FINDLAY CITY PLANNING COMMISSION

STAFF REPORT August 11, 2016

1. APPLICATION FOR SITE PLAN REVIEW #SP-18-2016 filed by AMEN, LLC, 1640 Tiffin Avenue, Findlay, OH for a parking lot to accommodate conversion of the structure to a chiropractic office at 1500 Tiffin Avenue, Findlay.

2. APPLICATION FOR FINAL PLAT #FP-05-2016 for Investek Subdivision, a two lot residential subdivision located on the west side of Technology Drive.

Final Plat of INVESTEK SUBDIVISION

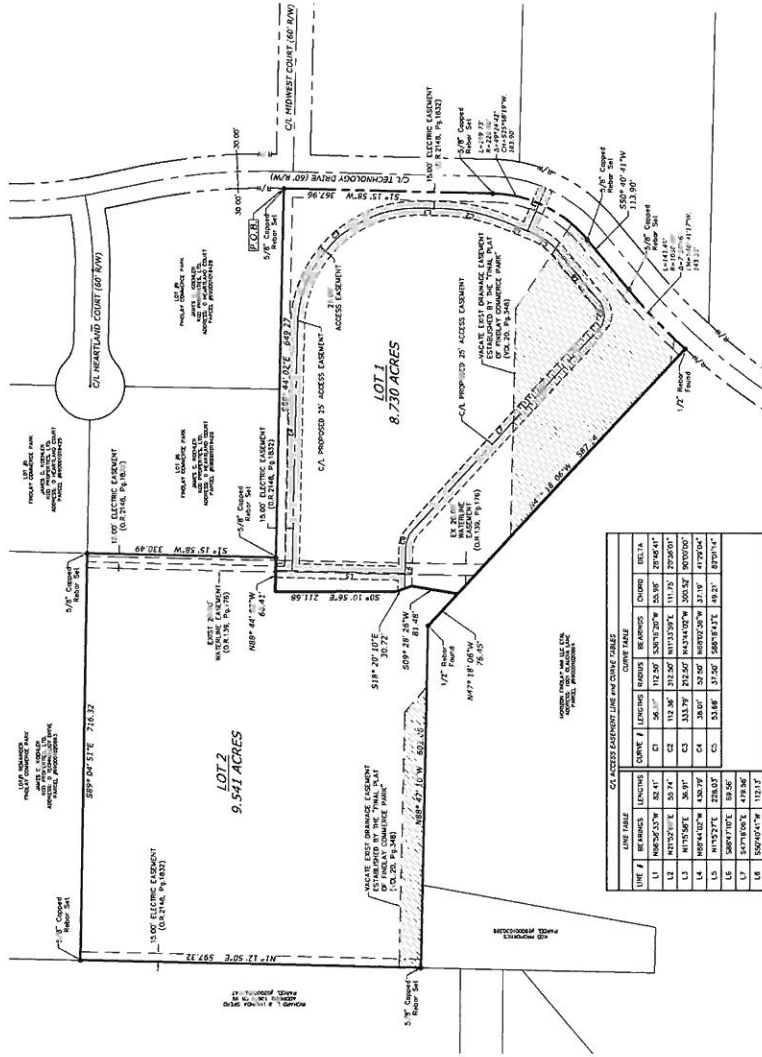
Engineering has never been told if the proposed water and sanitary that are going to be installed on Lot 1 are going to be public or private. We have no objection to the utilities being private but if they are going to be public, the easements should be added to the final plat. That way all of the easements will be shown on one document instead of multiple documents.

The owner's certification is the standard one that is used for subdivisions. It states that the owner "dedicate the roads and ways of width". Since no roads are being dedicated, it would be less confusing if this is removed from the certification.

There are a couple of dimensions/labels that need to be added. Engineering will work with the consultant to get these added.

- Add easements for the proposed water and sewer if they are going to be public.
- Revise the owner's certification to removing the road dedication wording

- **Add easements for the proposed water and sewer if they are going to be public. (ENG)**
- **Revise the owner's certification removing the road dedication wording (ENG)**
